| Model | | F200 Sorter Stapler | | | | | | Volt/Hz | Date of Modification | Serial Number | |

MODIFICATION BULLETIN NO. 6

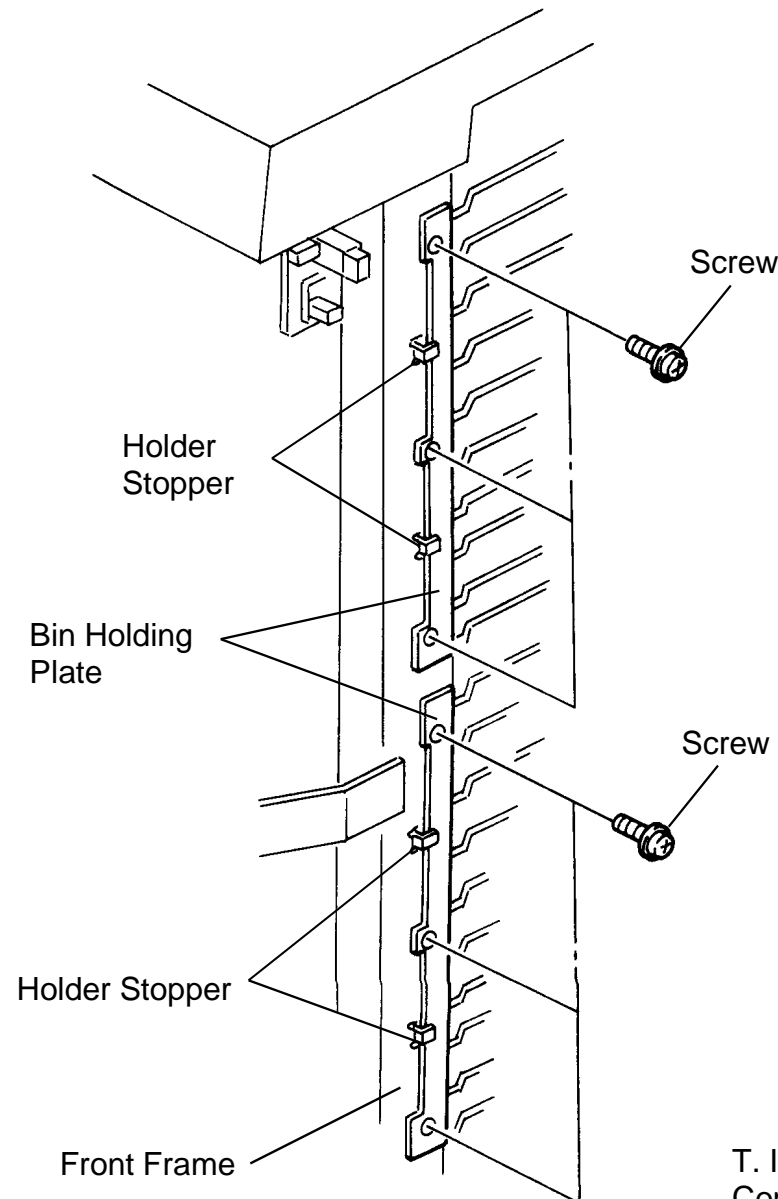
If the bins are pulled out strongly, the bins may sometimes be dislodged. This may cause a bin sensor malfunction. To correct this, the production machines have been modified as follows:

1. Two bin holding plates have been mounted on the front frame.
2. For these plates six screw holes and four holder stoppers have been made on the front frame. However, the part number of the front frame (A3544115, Index 25, Page 23) remains the same.

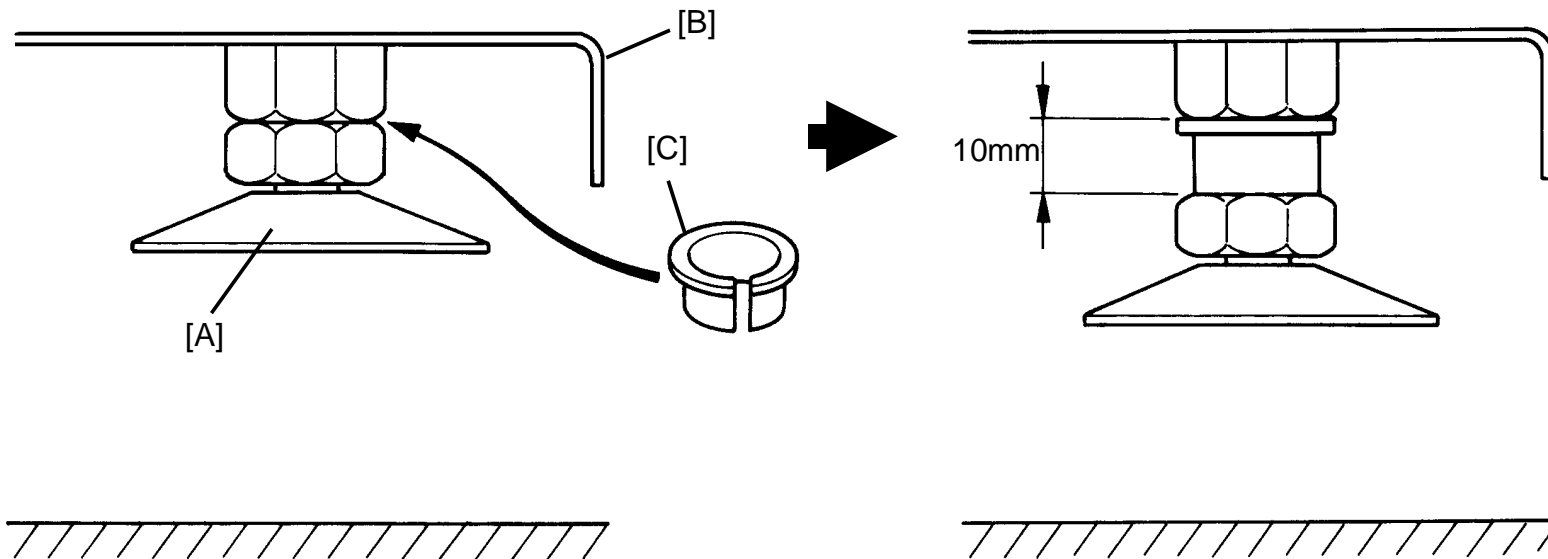
It is reported that when installing the sorter stapler, it is difficult to lower the screw stand [A] because the base plate [B] obstructs inserting the pliers.

To facilitate servicing, each screw stand is lonered and a busing [C] is inserted between the nut and the machine bottom.

As the stands are lonered, the leveling shoes have been changed to thinner ones.

The old leveling shoes cannot be inserted between the stands and the floor.

illustration A

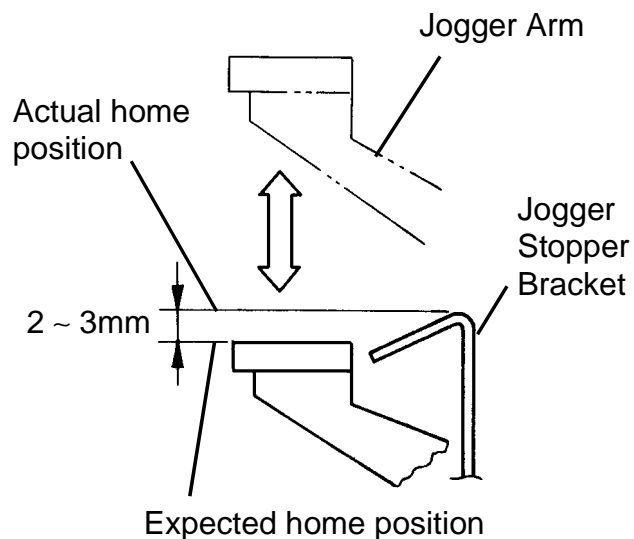
The jogger stroke is a few millimeters less than the expected value due to play between each gear. (illustration A)

illustration B

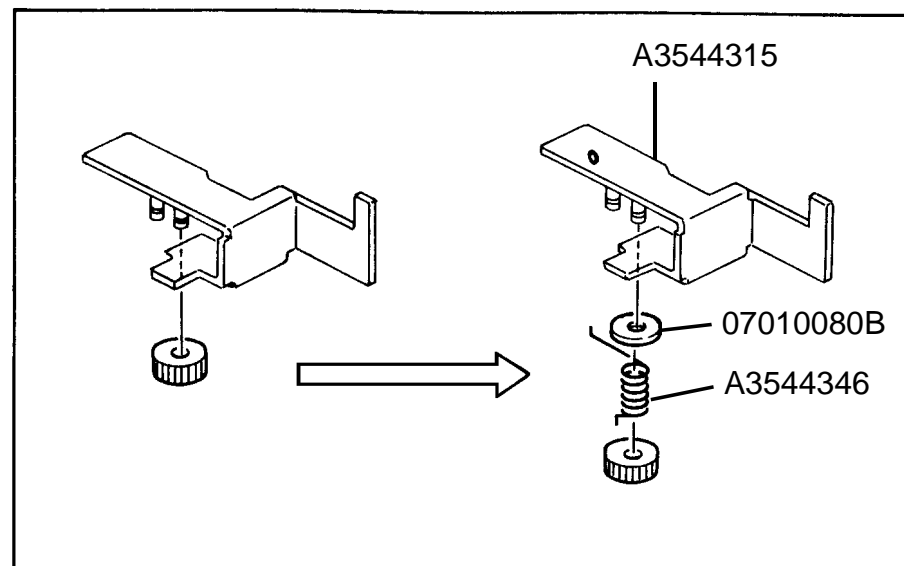
To return the jogger arm to the correct home position, a spring and a washer are added to the jogger unit. (illustration B)

Due to this modification a hole was made on the jogger bracket (A3544315) to hook the spring end. (The part number of the bracket has not been changed.)

When installing the spring and washer on a machine which does not have them, please change the jogger bracket (A3544315).

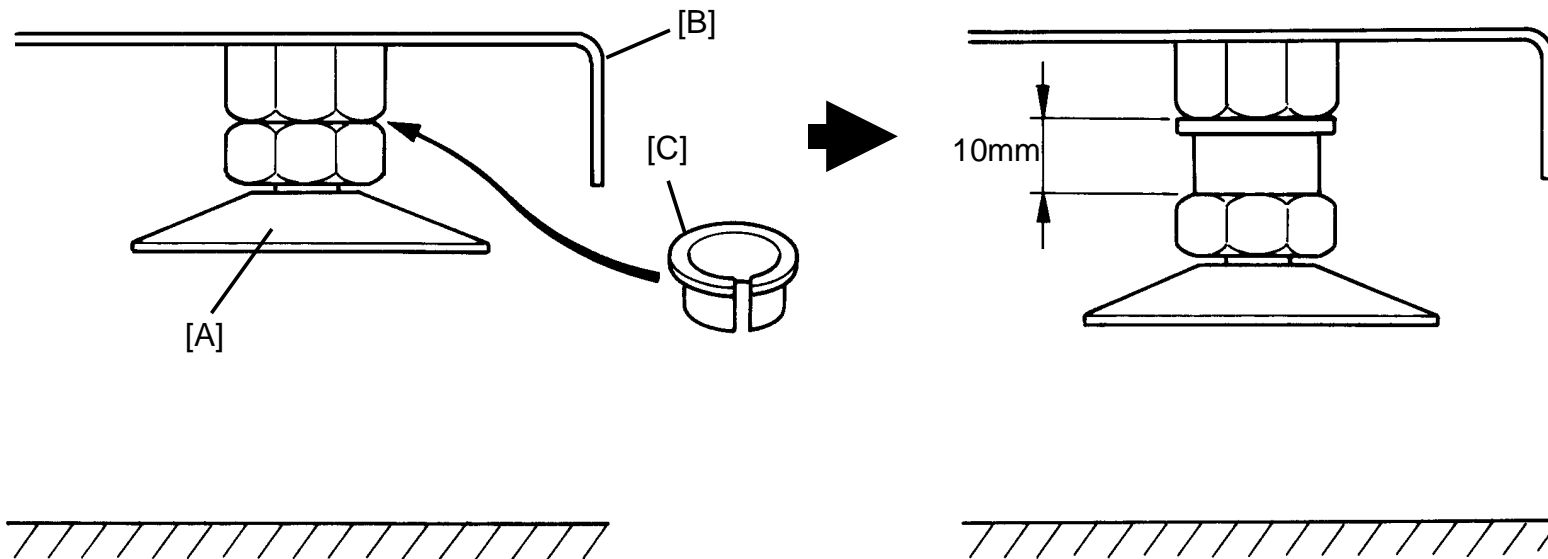
It is reported that when installing the sorter stapler, it is difficult to lower the screw stand [A] because the base plate [B] obstructs inserting the pliers.

To facilitate servicing, each screw stand is lowered and a busing [C] is inserted between the nut and the machine bottom.

As the stands are lowered, the leveling shoes have been changed to thinner ones.

The old leveling shoes cannot be inserted between the stands and the floor.

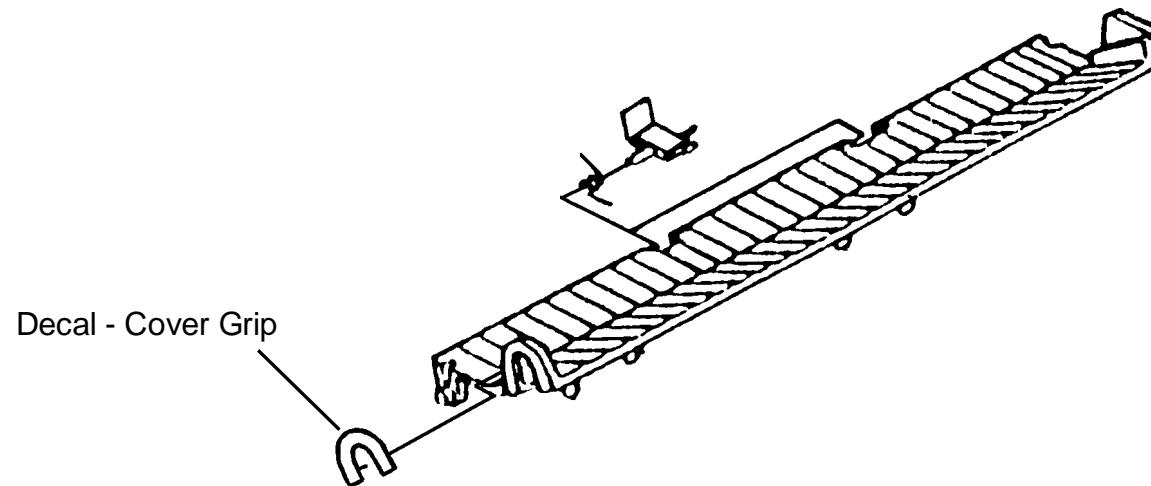
To indicate the handle of the upper entrance guide plate, a blue decal has been added. Users can easily find the handle to open the guide plate when removing misfed paper.

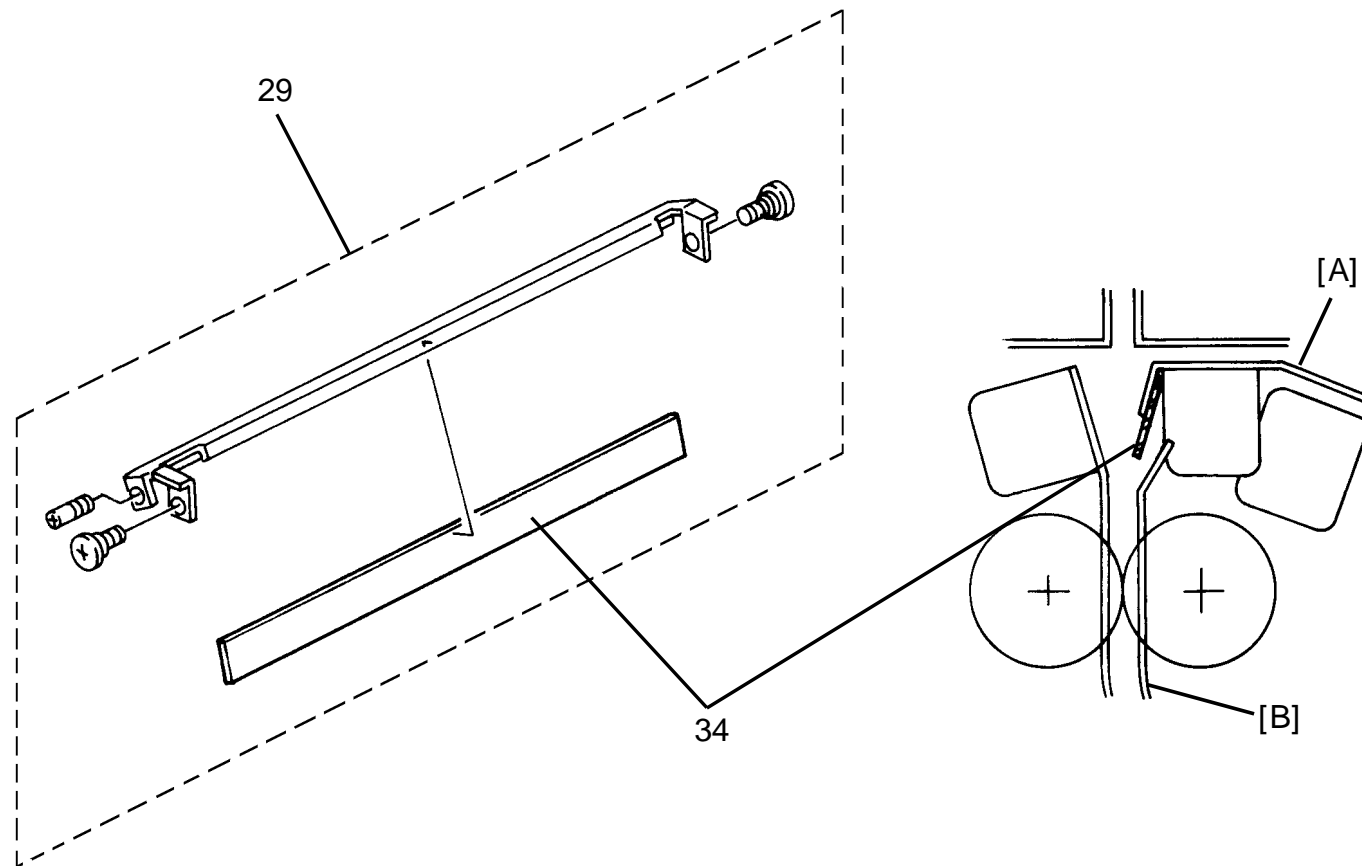
To prevent extremely curled paper from going between the Middle Guide Plate [A] and the Exit Guide Plate [B], a mylar has been added to the Middle Guide Plate.

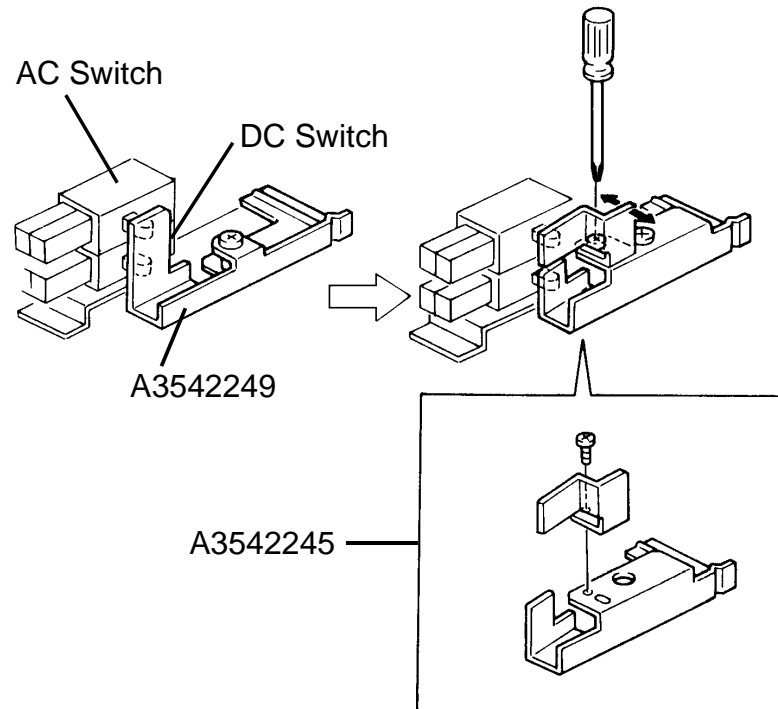
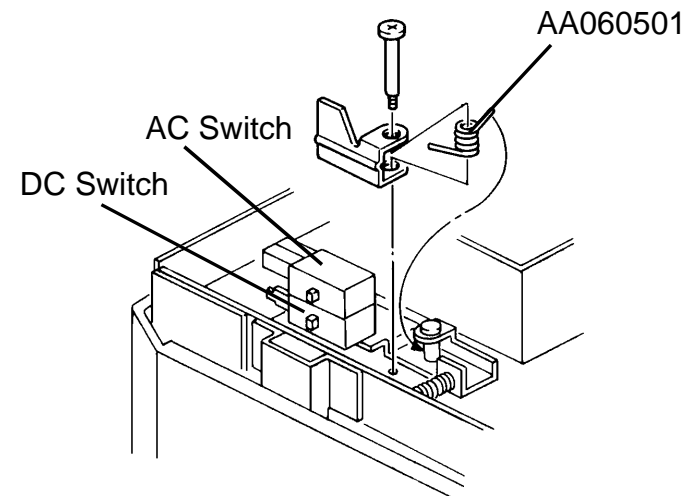
Each interlock switch for the Vertical Transport Cover and the Stapler Door consists of an AC switch in the upper position and a DC switch in the lower position. If only the DC switch is ON and the AC switch is OFF, the machine detects a closed door but the AC motor does not turn. This causes a paper jam and SC 720 is indicated.

1. To ensure that the AC switch is turned on before the DC switch, the Interlock Lever is divided into two parts. The upper switch actuator position can be changed so that the AC switch is always turned on before the DC switch. The Interlock Lever is supplied as an assembly.
2. If only the lower magnet catch of the Stapler Door is caught by the magnet, the door position may be balanced when only the DC switch is ON. To prevent this, the Interlock Switch Spring is added so that if the upper magnet catch is not caught by the magnet, neither the DC nor the AC switches is turned on.

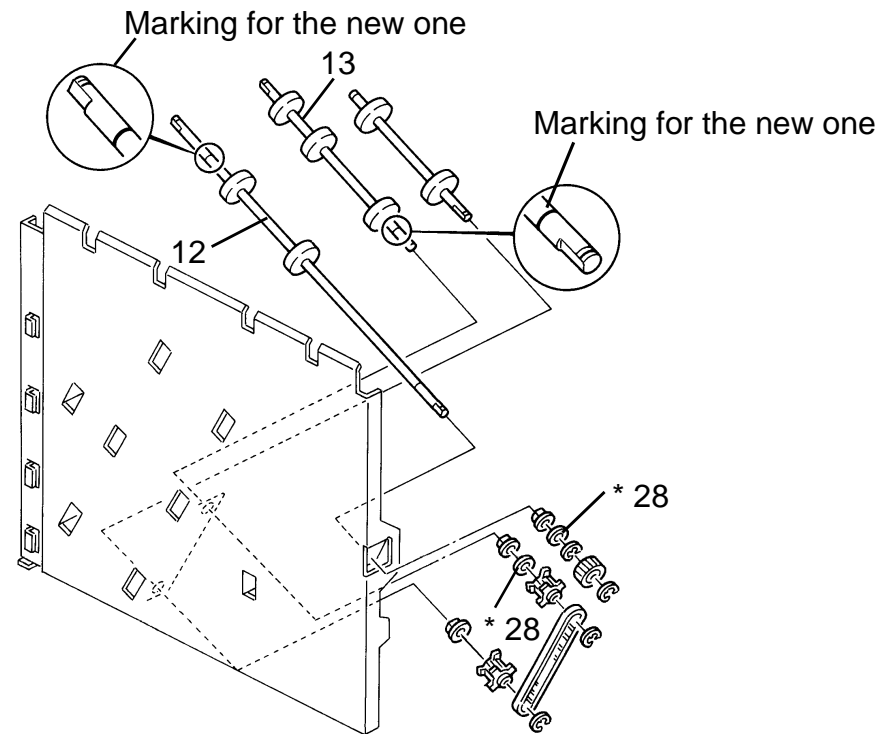
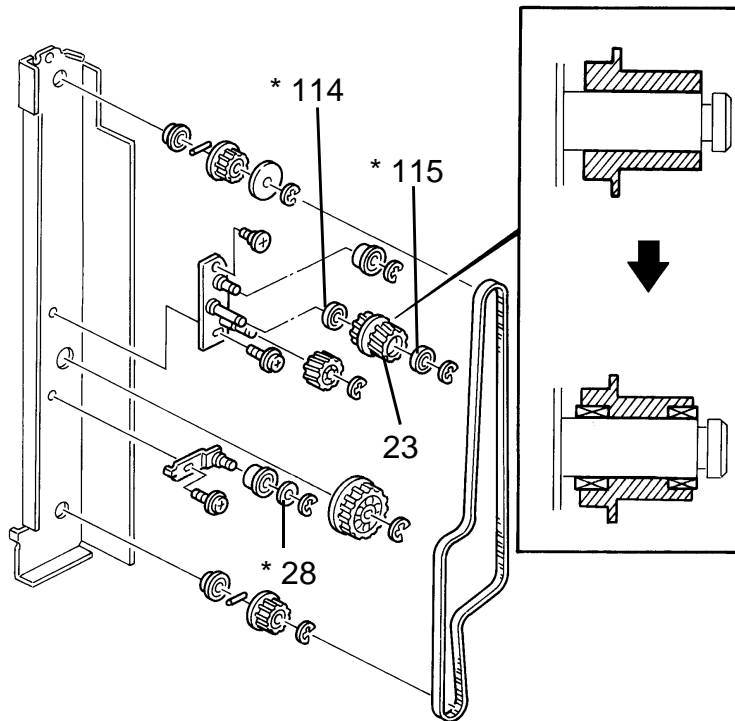
To reduce noise, the ball bearings have been added to the idle pulley gear. Besides, the spacers have been added to the transport rollers.

Accordingly, the position of the groove for the retaining ring on the transport roller has been changed.

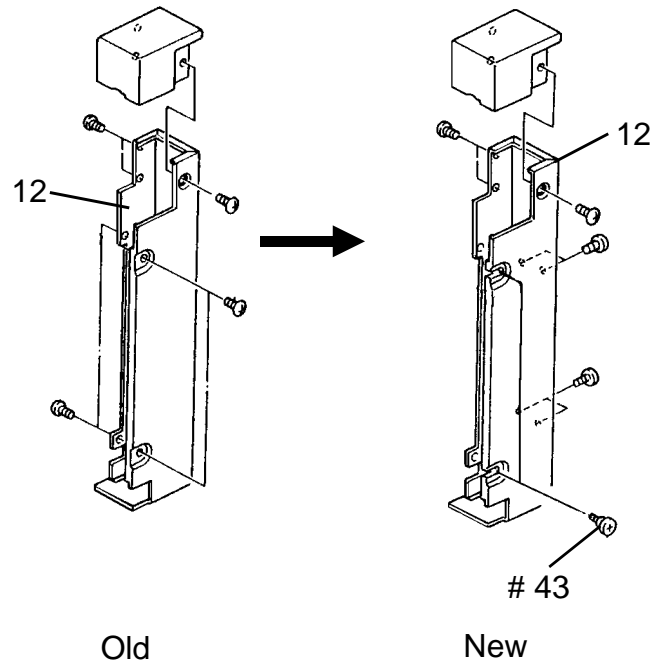
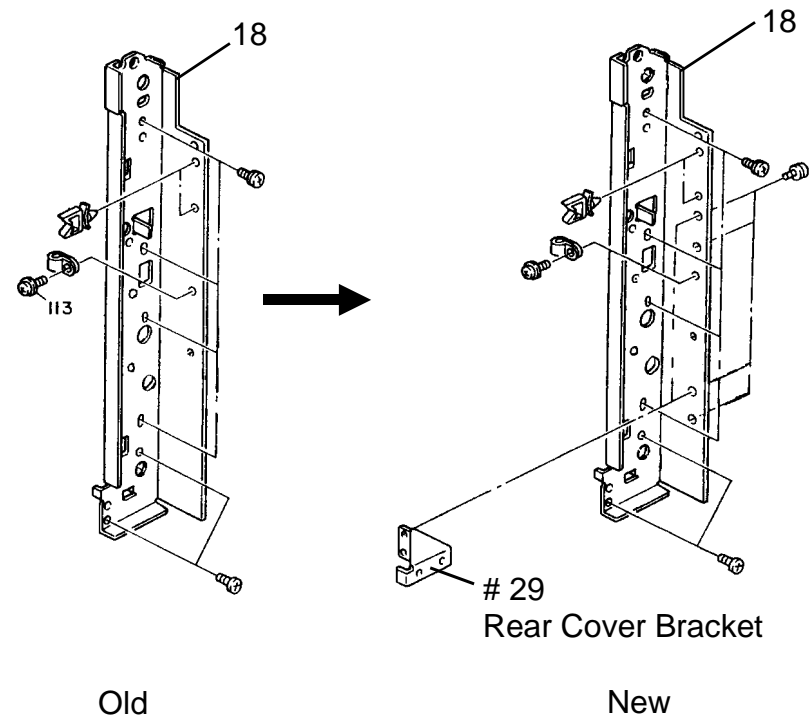
Due to parts standardization with other model, the following parts have been changed as shown.

12 Rear Diagonal Cover

18 Rear Side Plate - Diagonal

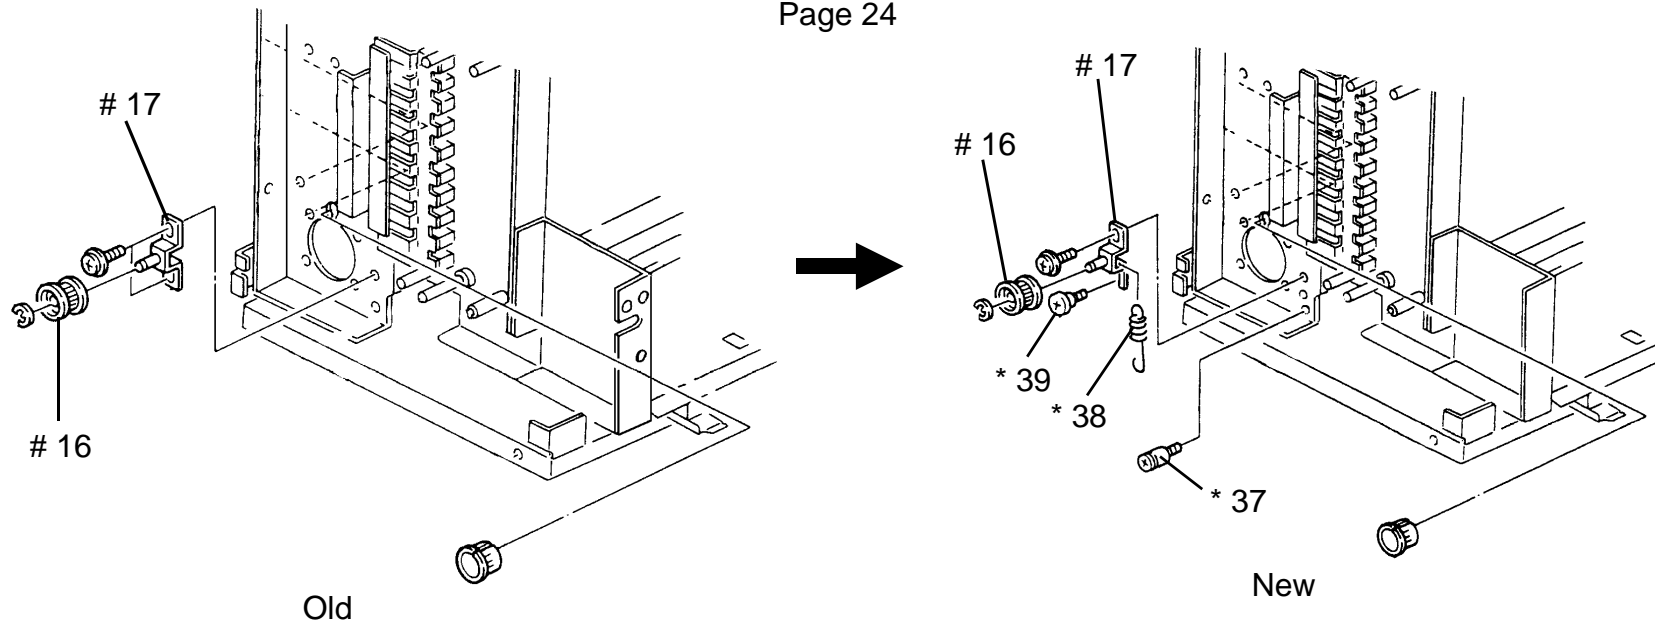
Due to parts standardization with other model, the idle pulley (#16) and adjusting pin (# 17) have been changed.

NOTE: The guide roller stud (# 37) and the adjusting spring (29.1mm) (* 38) can be installed in the new machine only.

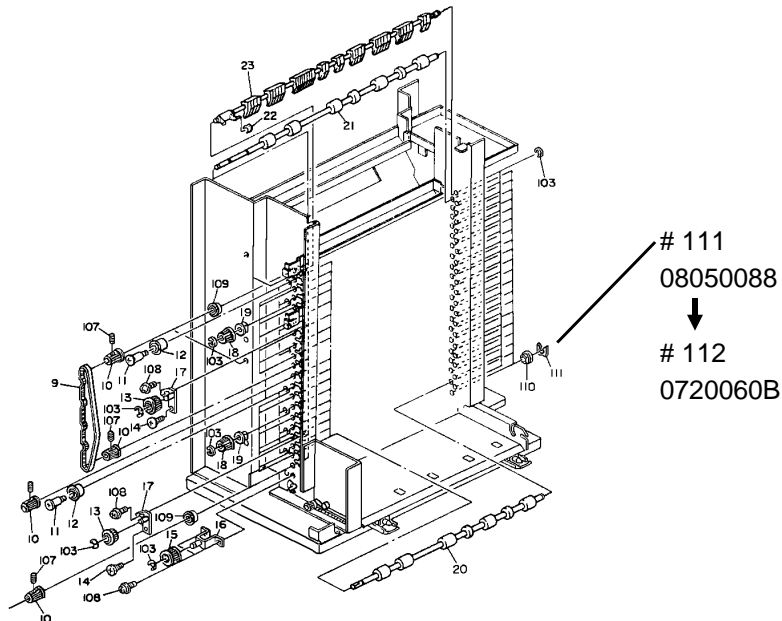
To improve durability, the retaining ring (which is mounted) on the 20th bin's long transport roller has been changed from resin to metal.
